Office Action Summary

10/505,352

DETAILED ACTION

FIG - 694 Spring Element

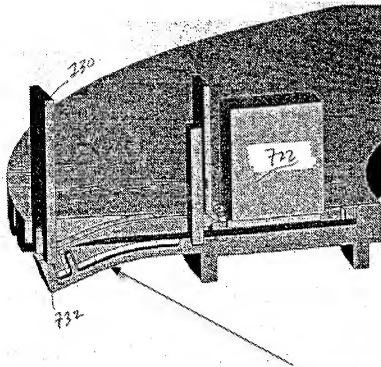
Regarding claim 80, Bobecker teaches the device wherein each of said spring elements comprises a generally U-shaped loop (each of the spring elements comprises a generally u-shaped loop, Figures 69* and see also Figure 65 a).
